CIVIL ENGINEERING ASSOCIATES, INC.

**Re: Development Application – Turf Care Center Redevelopment
Stowe Country Club, LLC
Project 7200 – 744 Cape Cod Road at 400 Cape Cod Road**

In accordance with guidance provided by the Development Review Board at the October 3, 2023 Site Plan and Conditions Use hearing, the applicant had revised and supplemented the application materials.

BUILDING "A" ENVIRONMENTAL
 MANAGEMENT CENTER
 DRAINAGE PLAN

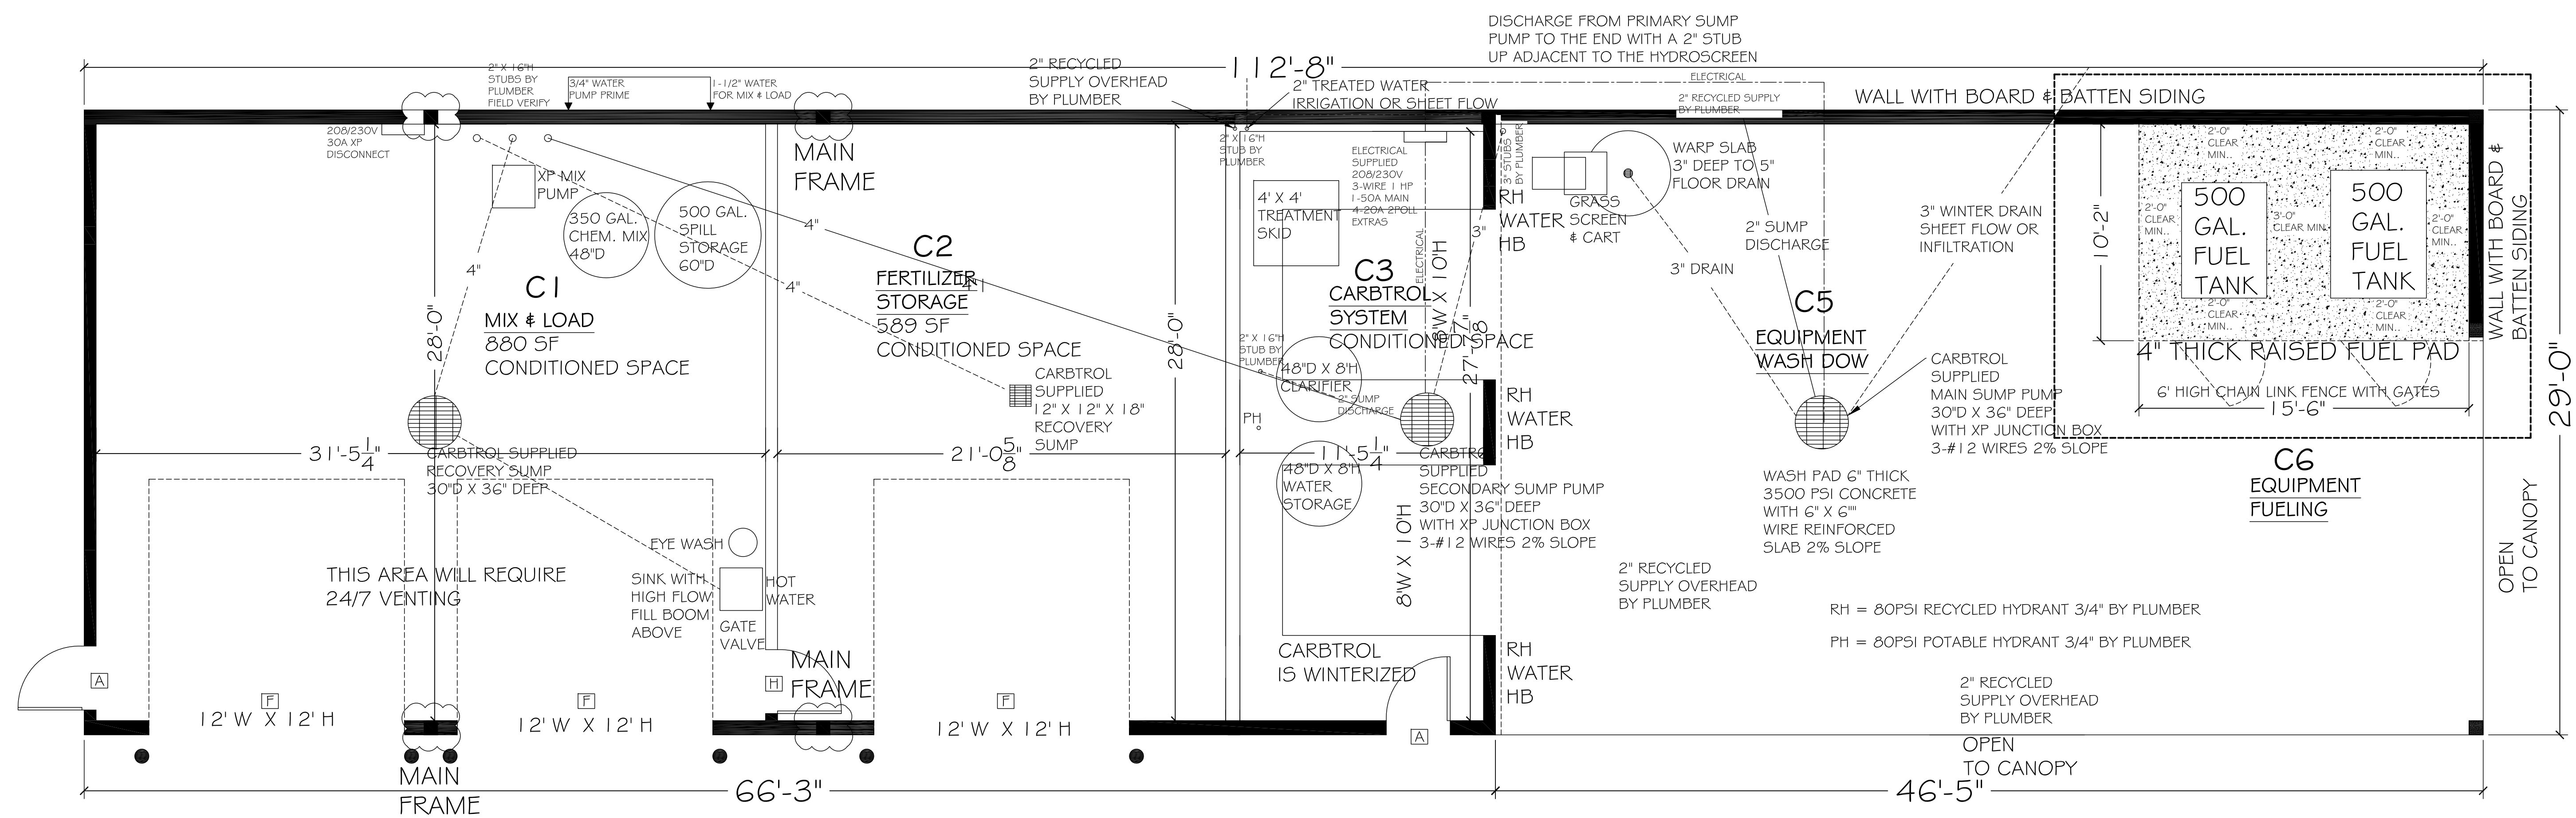
P1 – Building C Environmental Management Center Drainage Plan – Plan Added
